Name: Texaco Mini-Mart - 495 Pitkin Avenue - Site Plan Review

REVIEW COMMENTS

TITLE HEADING: Site Plan Review - Texaco Mini Mart

STAFF REVIEW

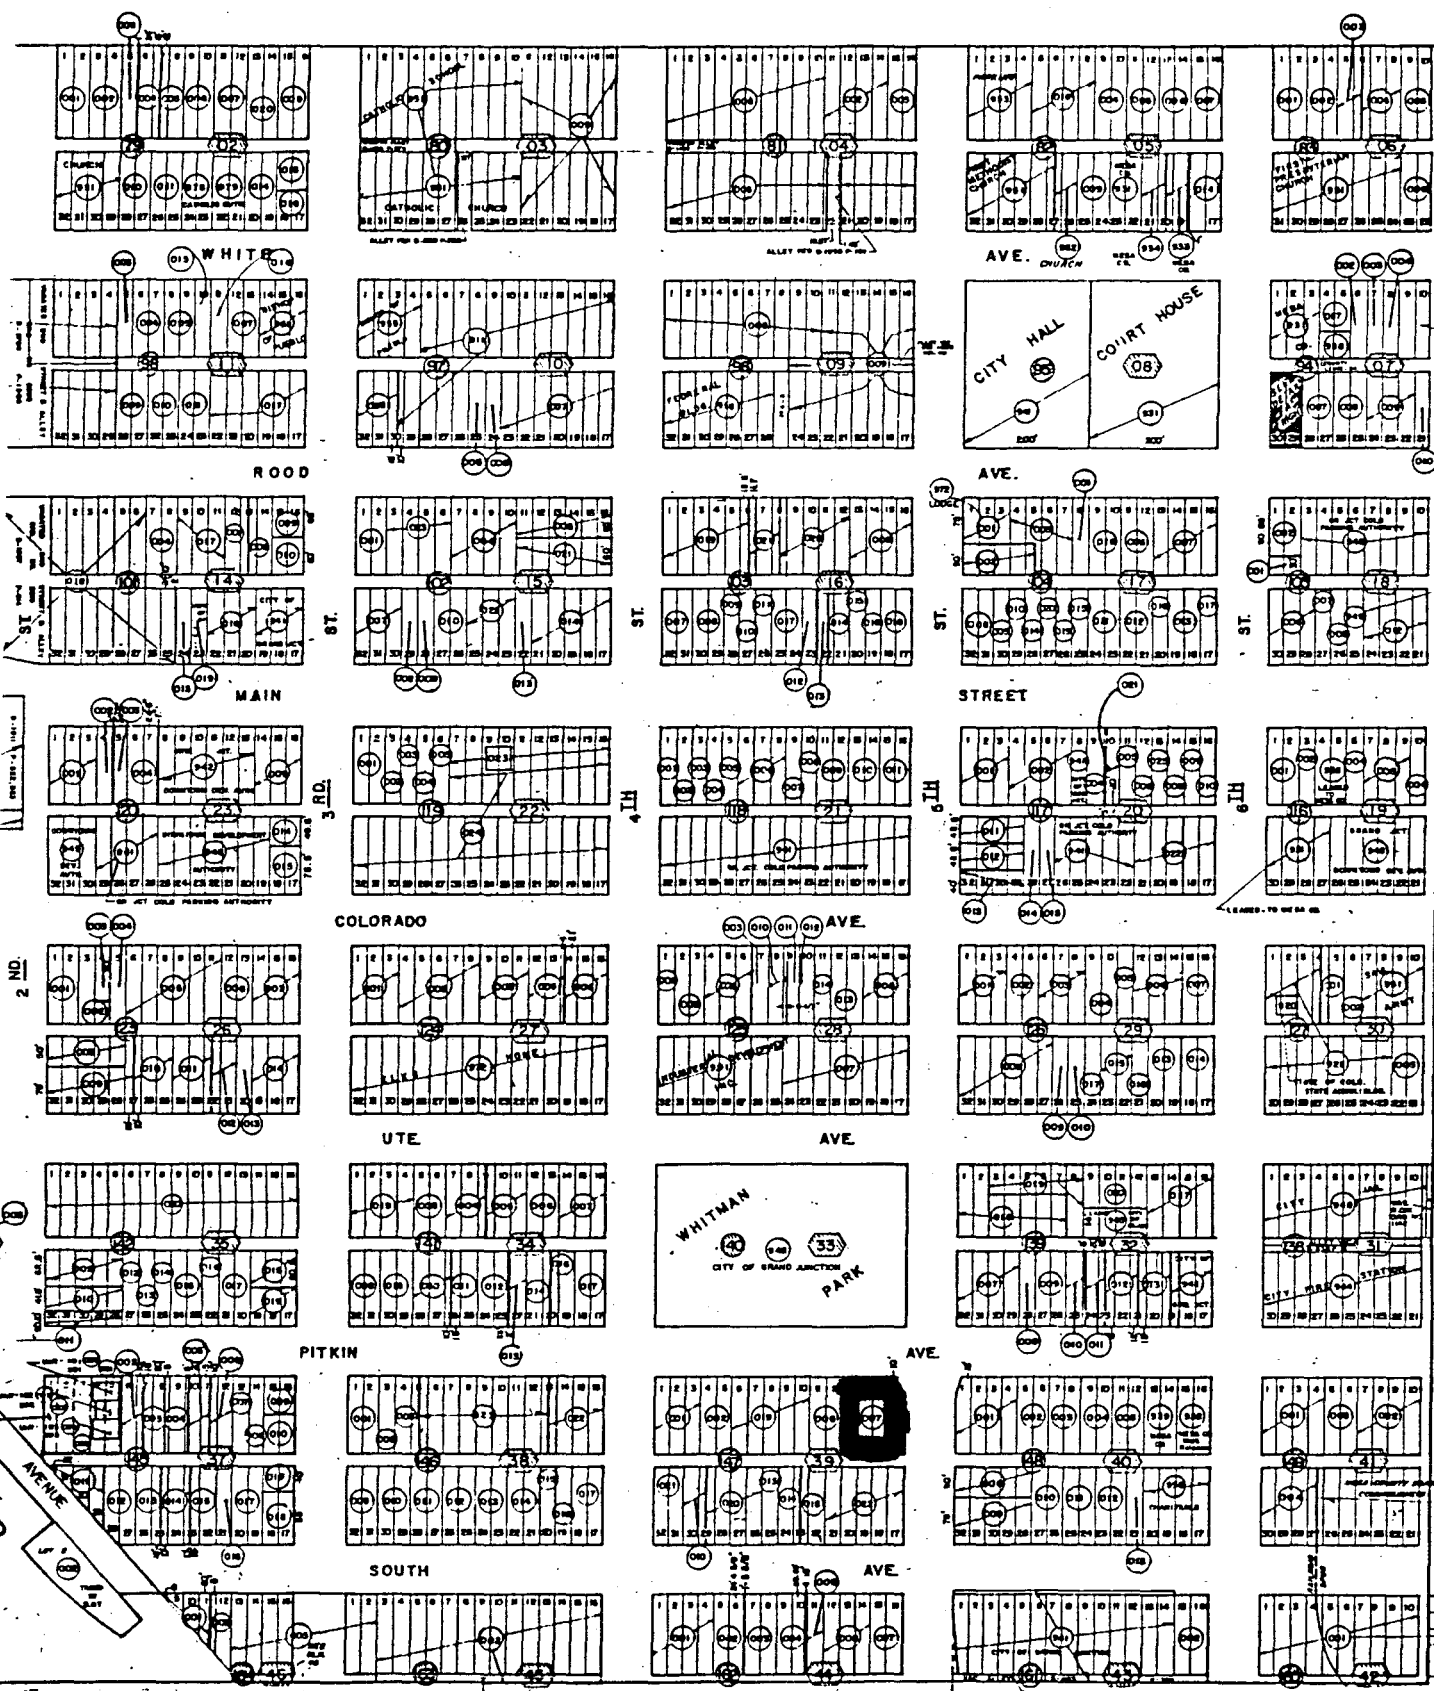
2. The asphalt area in the R.O.W that will be removed as part of this development and is not part of the driveway needs to be landscaped. As discussed with Gary Dean on May 27th, grass is an acceptable landscaping for that area.

4. The concrete sign base that is not being used needs to be removed.

6. Landscaping required for this development is being met by the 2177 sq ft proposed. The number of trees and the amount of shrub area meets the code requirement. The landscaping plan is approved as submitted with the addition of grass being planted in the R.O.W. area currently labeled as "Existing Asphalt".
